Access Compliance Report

Public Rights-of-Way

(Curb Ramps)

Intersection ID: 31497	Main Street: JORDANS_POND_LN	Cross Street: KONSLER_DR	Location: E
ADA ID: 9A38883EC364	Ramp Type: PerpDiag	Initial Pass/Fail: Fail	Overall Compliance: No
Severity Score: 25			
Codes/Mitigation Info/Possible Solution		Field Measurements/Component Compliance

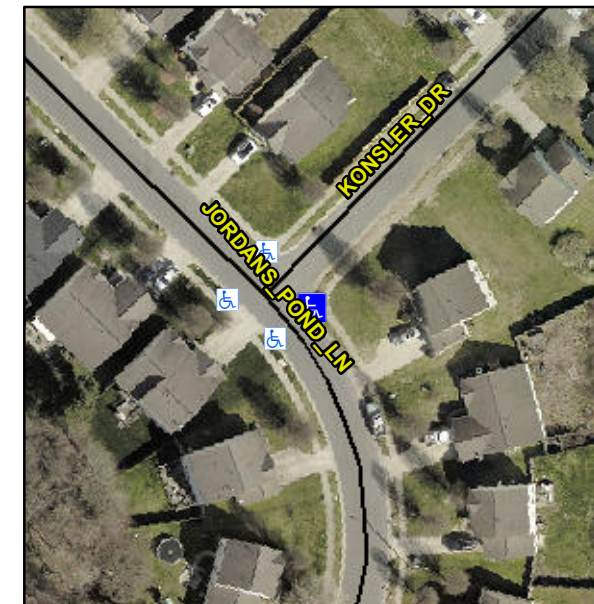
Not Found, R304.2.2, R304.5.3

Compliance	Description	Data	Compliance	Description	Data
N/A	Ramp Length (in)	47.0	No	Ramp Slope (%)	9.6
Yes	Ramp Width (in)	49.0	No	Ramp XSlope (%)	5.9
N/A	Flare Type LT	N/A	N/A	Flare Type RT	N/A
N/A	Flare Slope LT (%)	N/A	N/A	Flare Slope RT (%)	N/A
N/A	Flare Traversable LT?	N/A	N/A	Flare Traversable RT?	N/A
N/A	Landing Length (in)	N/A	N/A	DWS Provided?	N/A
N/A	Landing Width (in)	N/A	N/A	DWS Contrast?	N/A
N/A	Landing Slope (%)	N/A	N/A	DWS Length (in)	N/A
N/A	Landing X Slope (%)	N/A	N/A	DWS Full Width?	N/A
N/A	Landing Curb? (Y/N)	N/A	N/A	DWS Offset (in)	N/A
N/A	Shared Landing?	N/A			
N/A	Gutter Ponding?	N/A	N/A	Gutter Slope (%)	N/A
N/A	Gutter Lip Ht (in)	0.5	N/A	Gutter X Slope (%)	N/A
N/A	Painted X Walk1?	No	N/A	Painted X Walk2?	No
	X Walk 1 Direction	To NW		X Walk 2 Direction	To SW
N/A	X Walk 1 Width (in)	N/A	N/A	X Walk 2 Width (in)	N/A
	X Walk 1 Slope (%)	1.3		X Walk 2 Slope (%)	4.2
	X Walk 1 X Slope (%)	1.4		X Walk 2 X Slope (%)	2.9

Remove & Replace Curb Ramp With Two New Directional Ramps or Equivalent.
